# LONEDELL R-14 SCHOOL DISTRICT

## June 4, 2026, Bus Garage Committee Meeting Minutes

Project Name: **Lonedell Bus Garage** Meeting Date: **06/04/2026**

### 95% PAGE TURN REVIEW MEETING

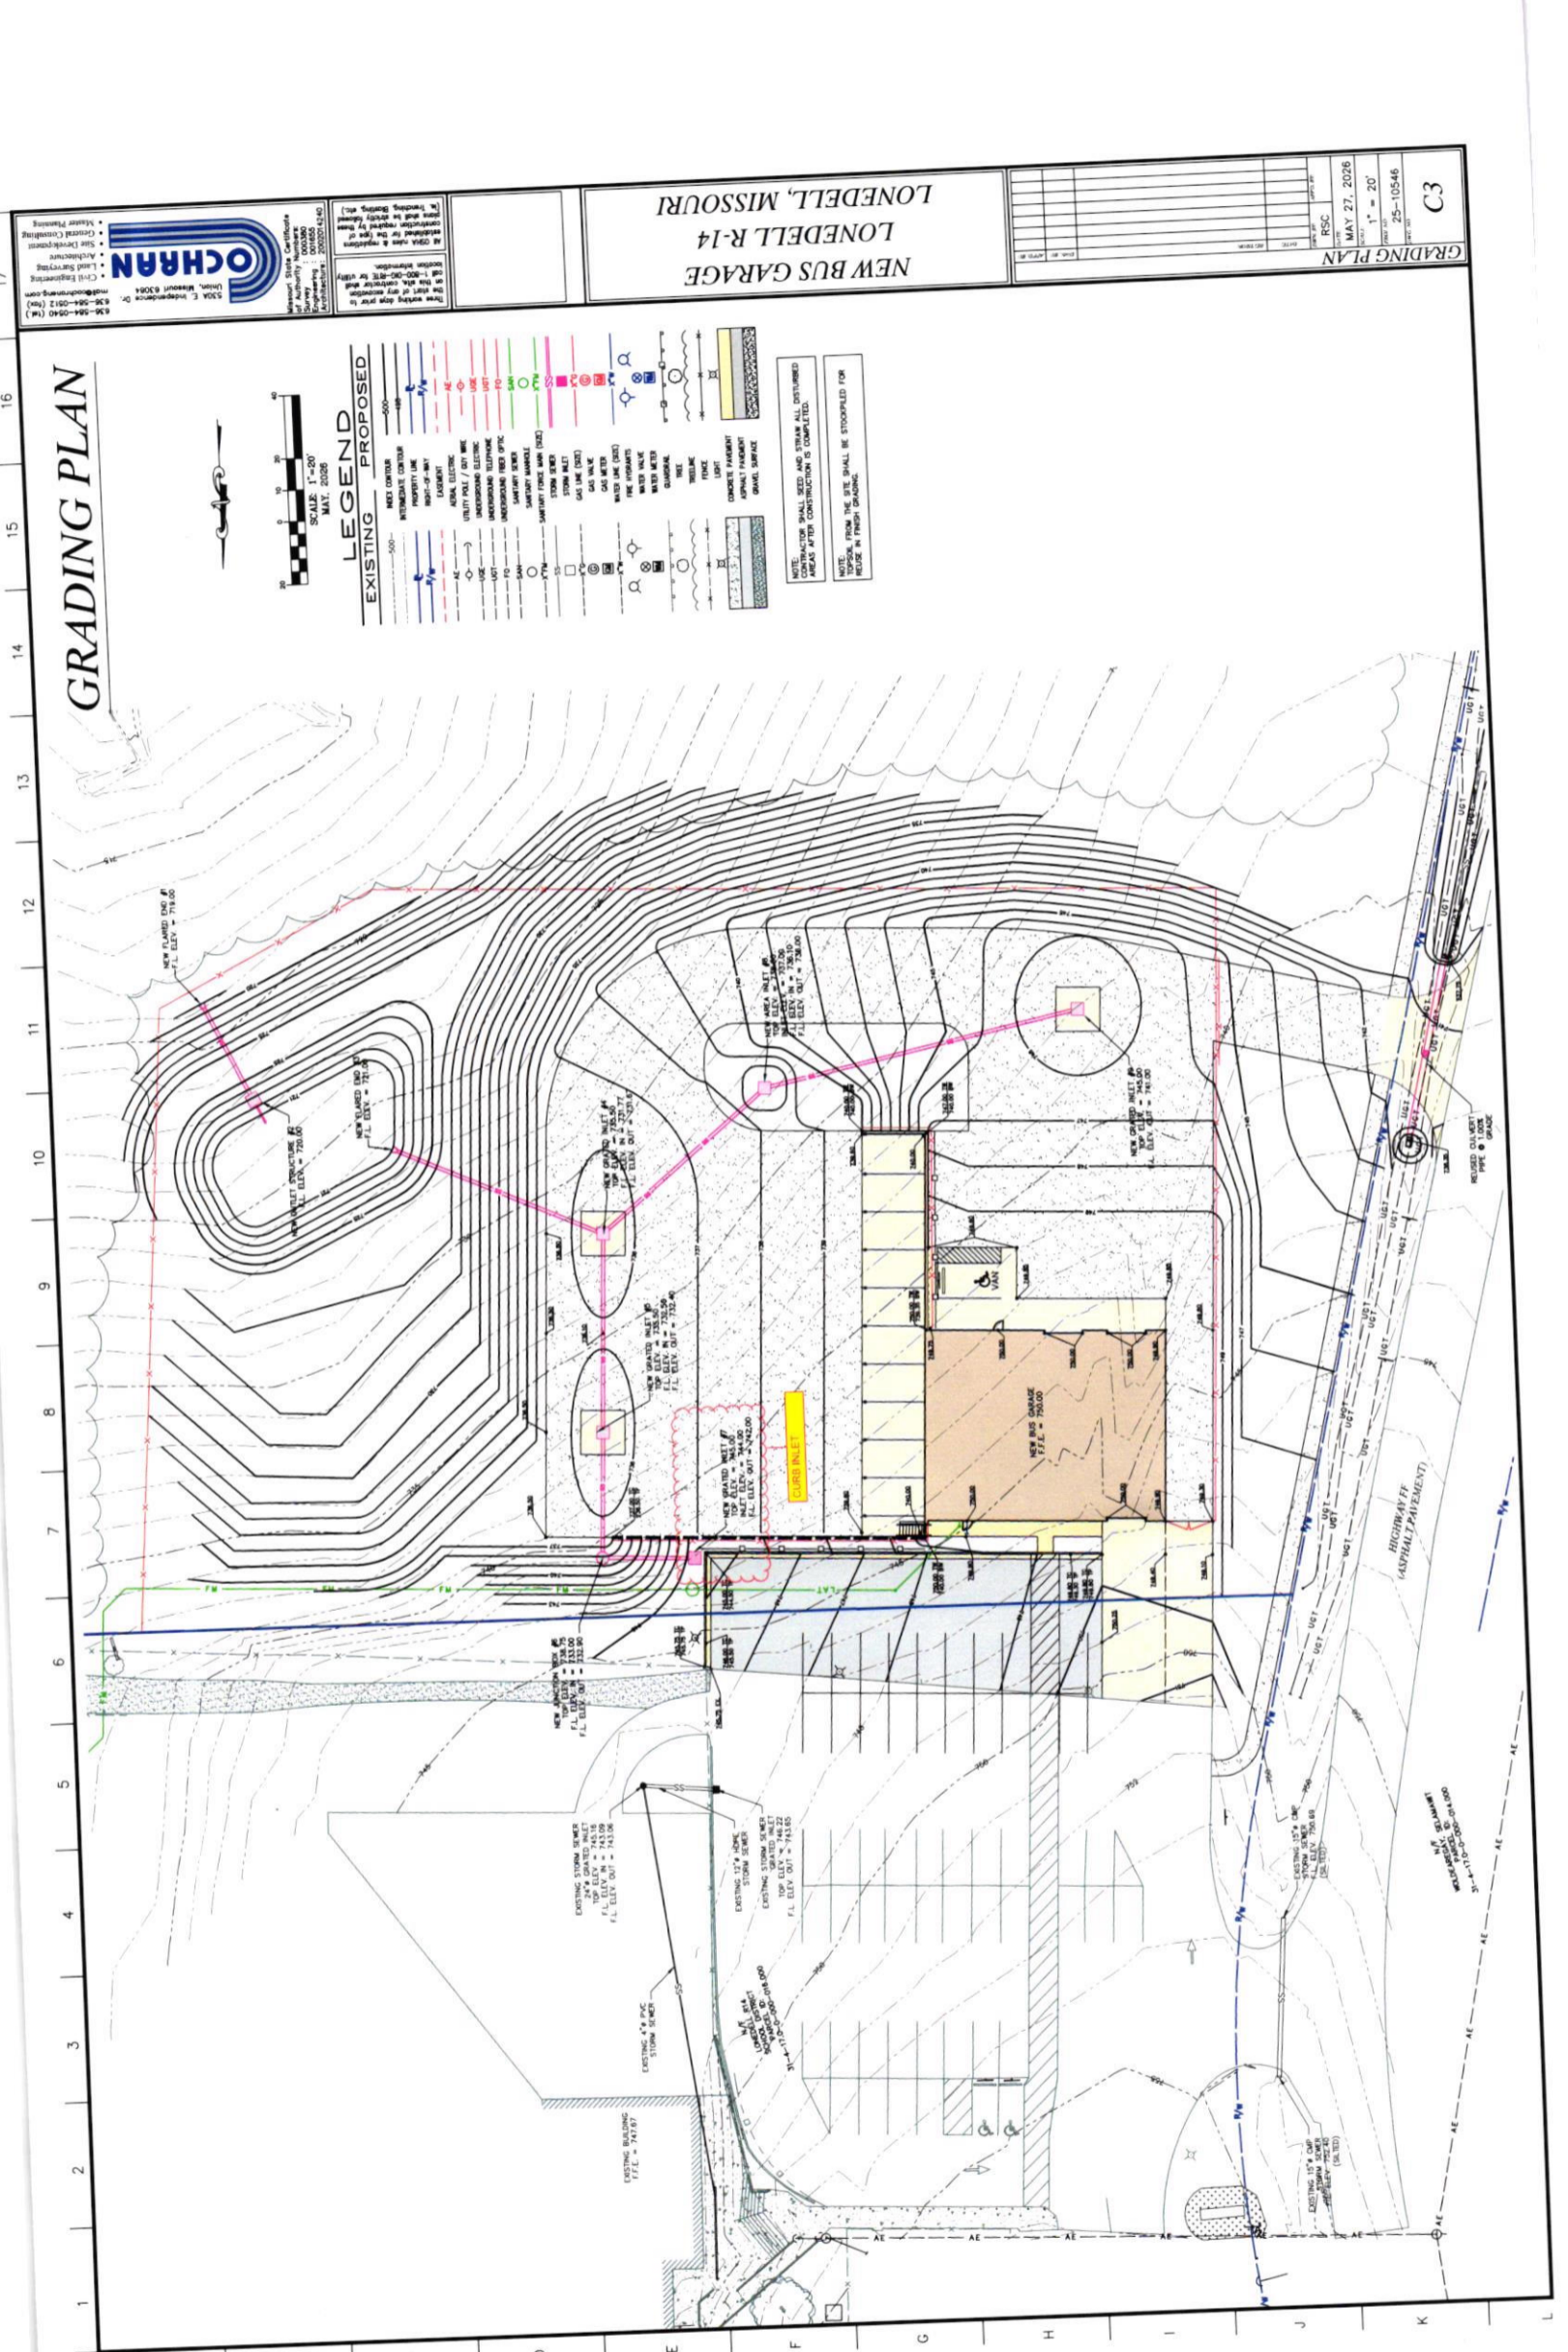
- i. Current arrangement accepted.
- c. **Interior Liner Panel Height Coordination** – The team reviewed the proposed liner panel heights within the maintenance bays and identified discrepancies between drawing references showing both 8'-0" and 10'-0" liner panel heights.

1A - PREFINISHED INTERIOR LINER PANELS SYSTEM IN MAINTENANCE AREA.  
PROVIDE PREFINISHED 10'-0" TALL METAL LINER PANELS AT THE FULL INTERIOR PERIMETER OF THE MAINTENANCE GARAGE AREA. PROVIDE 8" FIRE-RETARDANT TREATED PLYWOOD SHEATHING BEHIND THE LINER PANEL SYSTEM. LINER PANEL SYSTEM SHALL BE INSTALLED OVER THE BASE METAL BUILDING AND INSULATION SYSTEM AND IN ACCORDANCE WITH THE PERM MANUFACTURER'S RECOMMENDATIONS.  
BASE BID SHALL INCLUDE EXPOSED VINYL-FACED METAL BUILDING INSULATION AT THE PERIMETER WALLS OF THE MAINTENANCE GARAGE AREA.  
1B - PREFINISHED INTERIOR LINER PANELS SYSTEM IN BUS PARKING BUS PORT.  
PROVIDE PREFINISHED 8'-0" - 12'-0" TALL METAL LINER PANELS AT THE INTERIOR PERIMETER OF THE BUS PARKING BUS PORT AREA AND UNDER THE ROOF TYPICAL LINER PANEL SYSTEM SHALL BE INSTALLED OVER THE BASE METAL BUILDING DIRECTLY OVER WALL GIRTS AND UNDER ROOF PURLINS AND IN ACCORDANCE WITH THE PERM MANUFACTURER'S RECOMMENDATIONS.

- i. The District reviewed the proposed liner panel extents and confirmed a preference for 8'-0" liner panels within the maintenance bays.
  - ii. The Design Team will revise the construction documents to eliminate conflicting information and provide a consistent 8'-0" liner panel height within the maintenance bays.

8'-0" HEIGHT IS ACCEPTABLE

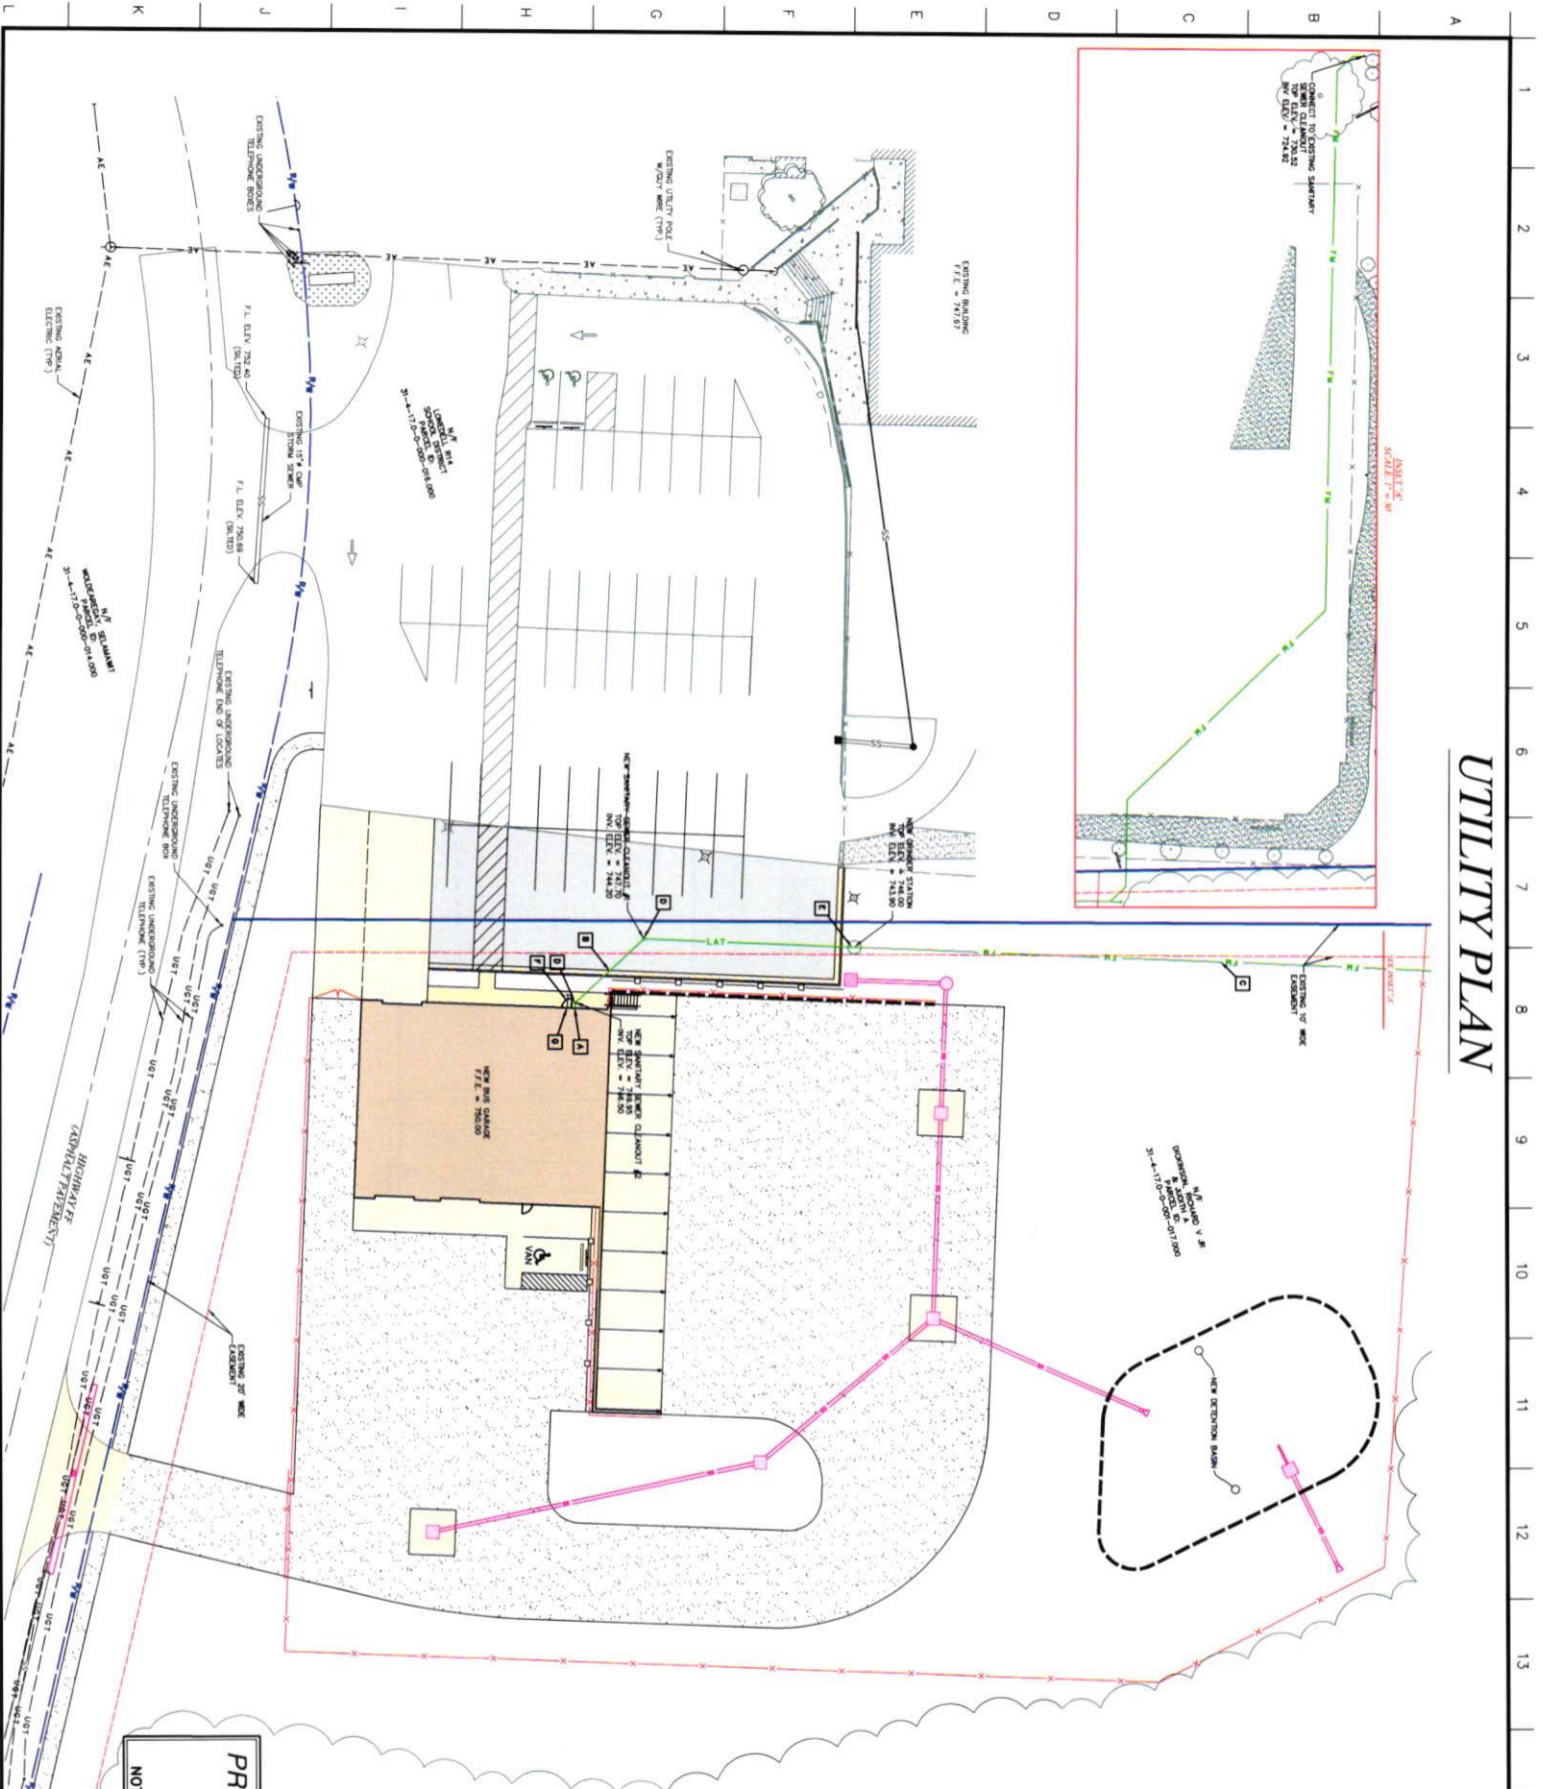
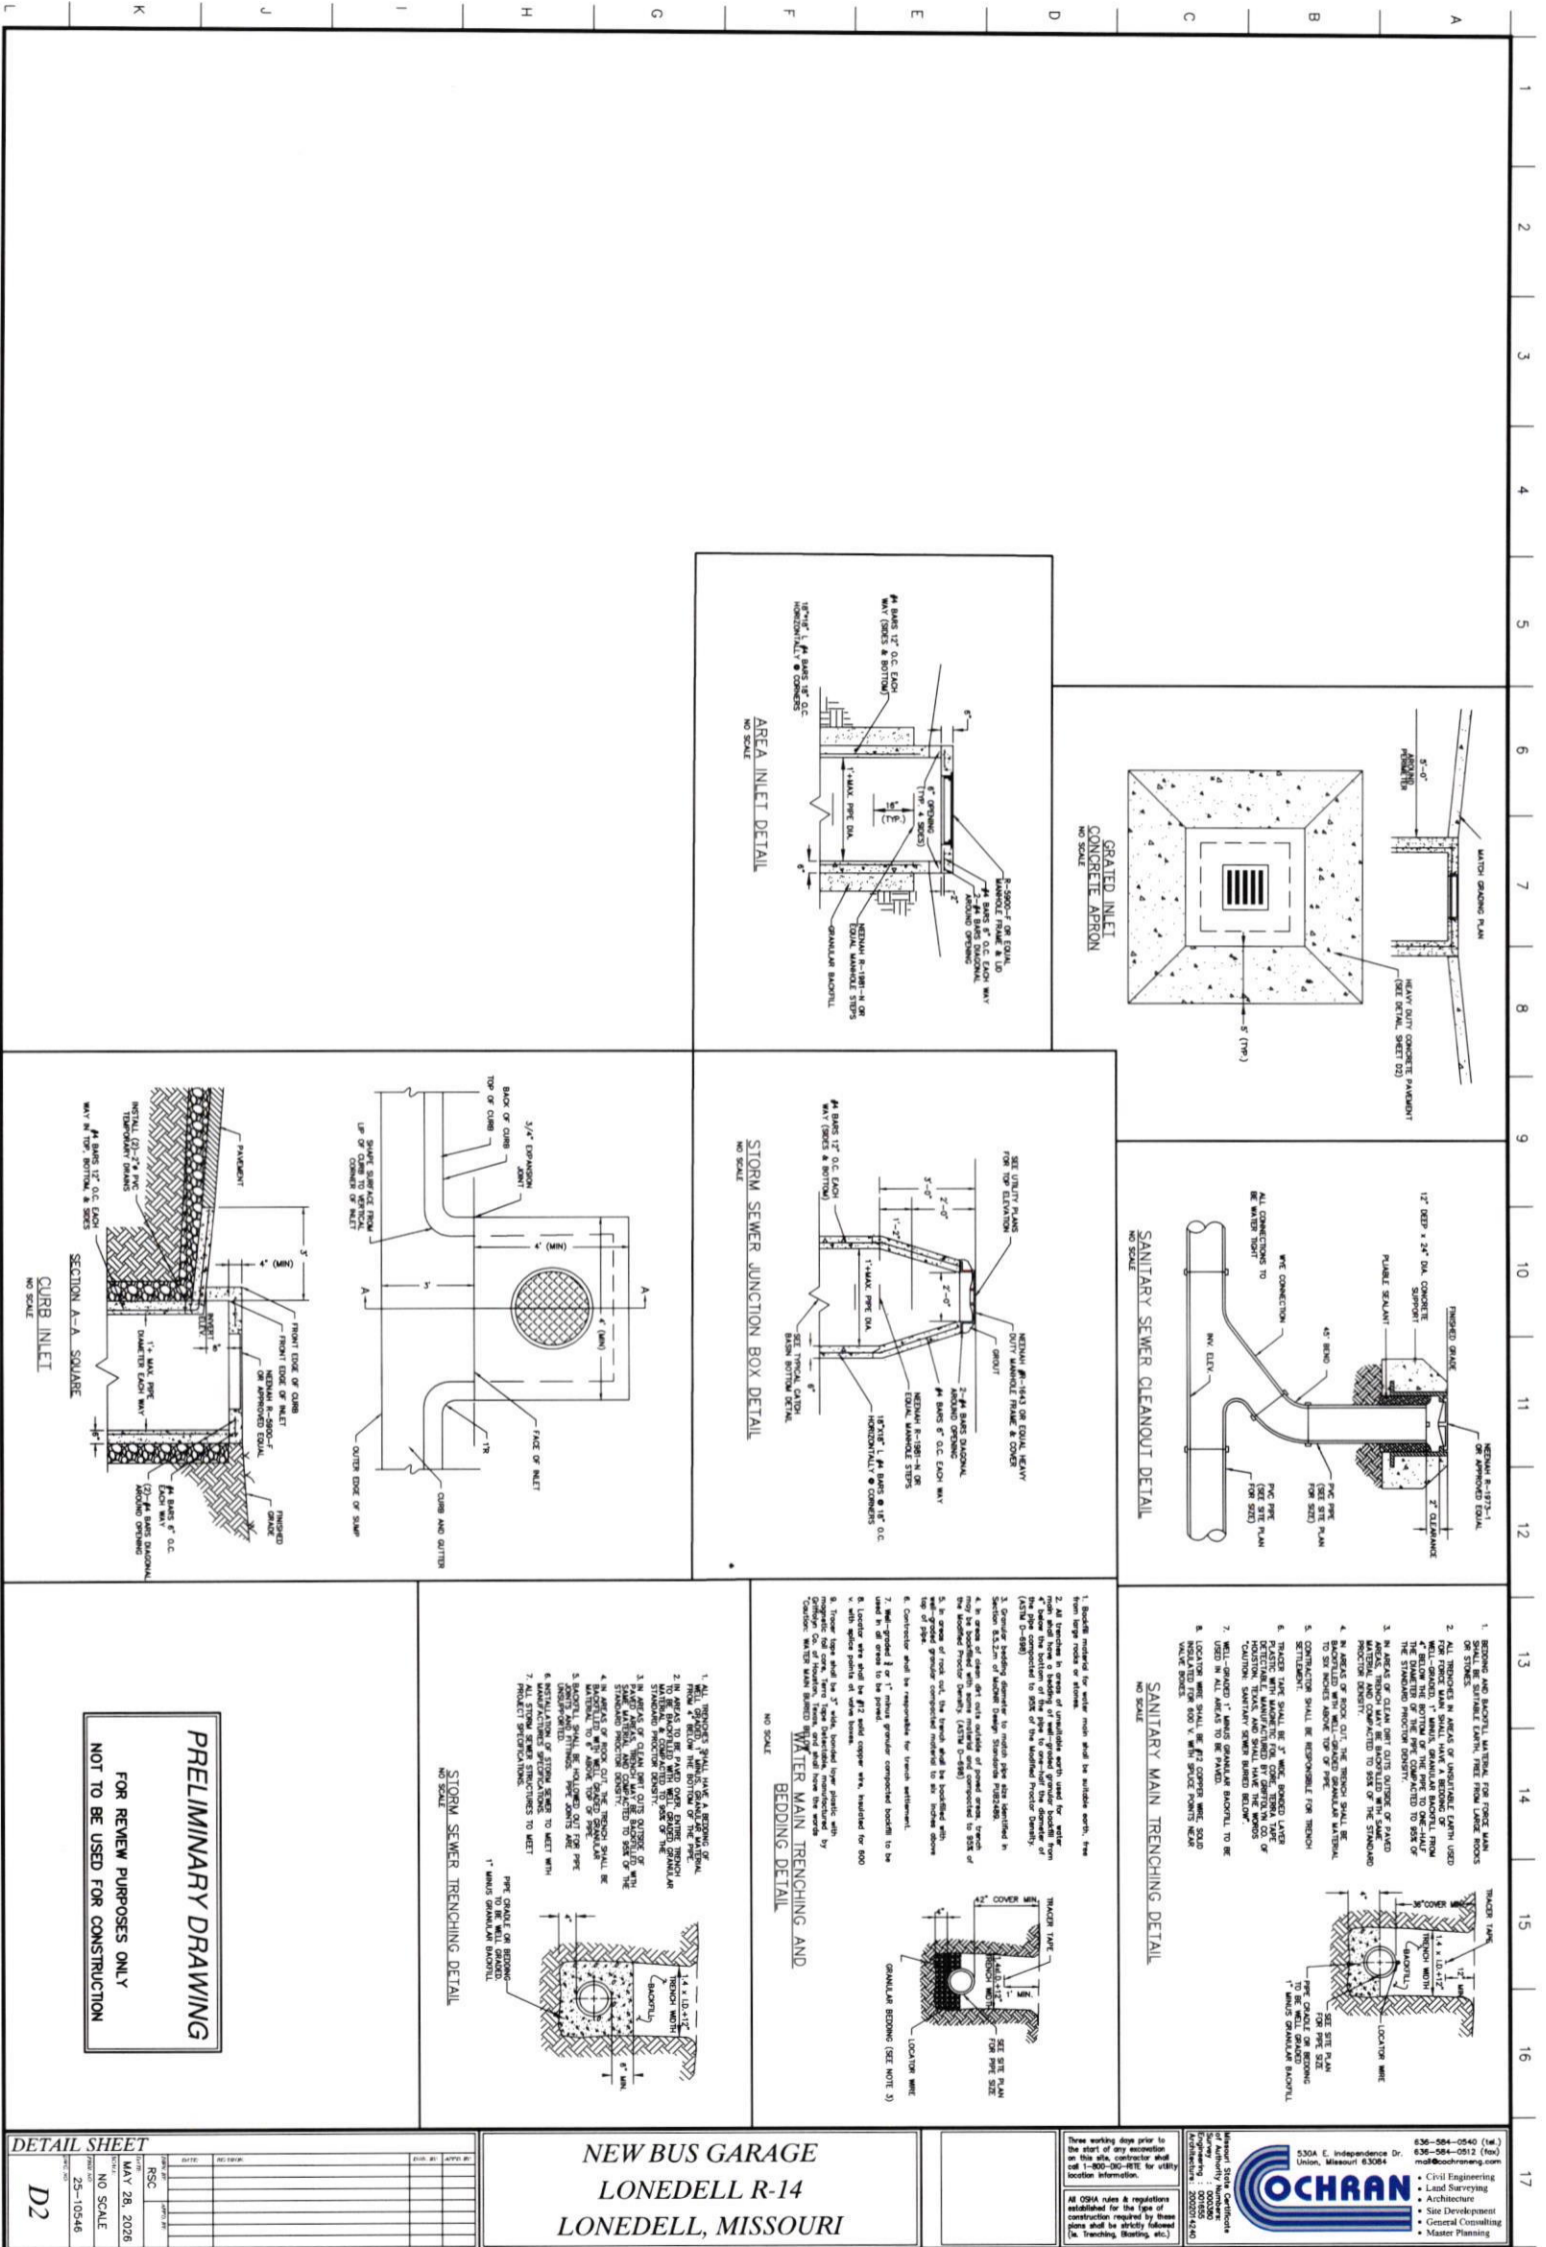
- i. A curb inlet is anticipated at the southeast corner of the parking lot.
  - ii. Cochran Engineering to confirm inlet type and final configuration.
- g. **Utility Routing and Directional Boring** – The team reviewed utility routing between the existing school building and the proposed bus garage, including water service, fiber connectivity, and technology infrastructure. Discussion focused on minimizing impacts to the recently resurfaced parking lot, coordinating demolition of existing utility connections, and evaluating directional boring versus open-cut installation methods.

- i. Coordinate the limits of demolition associated with the existing water service.
  - ii. Coordinate routing of the new water service to the bus garage.

- iii. Coordinate routing requirements for future fiber connectivity and technology infrastructure between the existing school building and the proposed bus garage.

- iv. Cochran Engineering indicated that directional boring may be comparable in cost, or potentially less expensive, than open-cut installation due to the relatively small water service size.

- v. The District indicated a preference to avoid saw-cutting the existing parking lot if possible due to the recent overlay and planned seal coat / restriping work.

- vi. Water service, fiber, and future technology infrastructure should be coordinated to minimize the number of crossings between the existing building and the bus garage.

- vii. Directional boring remains the preferred approach pending final utility coordination.
